Appendix 4A

A467 Speed Limit Review

A467 – Remediation Measures

Figure F9: The proposed speed limit changes along Caerphilly Mountain

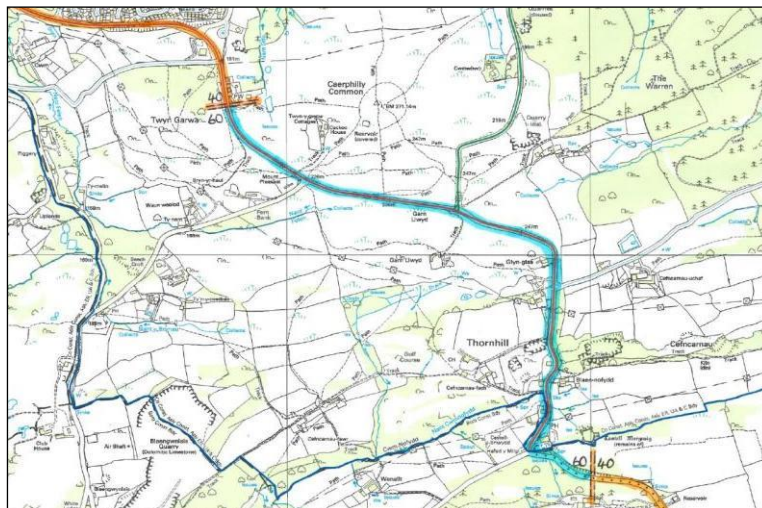
Although the national speed limit is suitable for the majority of the link, it feels too high for the winding, undulating section next to the boundary, where vehicles are likely to be travelling below 40mph. To provide an accurate assessment of the link it

has been split into two different zones, 22A represents the northern section, and 22B representing the southern section. No speed data has been collected in 22B, however it is possible to provide collision rates for both sections by using the A.A.D.T figure collected from the original data.

The collision rate in the winding section is high and above the threshold of 35 collisions per 100 million vehicle kilometres. A reduction in the speed limit from national to 40mph could assist in reducing the collision rate figure and provide a safer environment for motorists. It would also fit in with the 40mph limit on the other side of the boundary in Cardiff.

Reduce the southern part of the link that contains a winding, undulating carriageway from the current national speed limit to 40mph. The proposed site for the new speed limit change from national to 40mph can be seen in Figure C9, where the **orange route represents a 40mph limit** and the **blue route represents a national speed limit**.
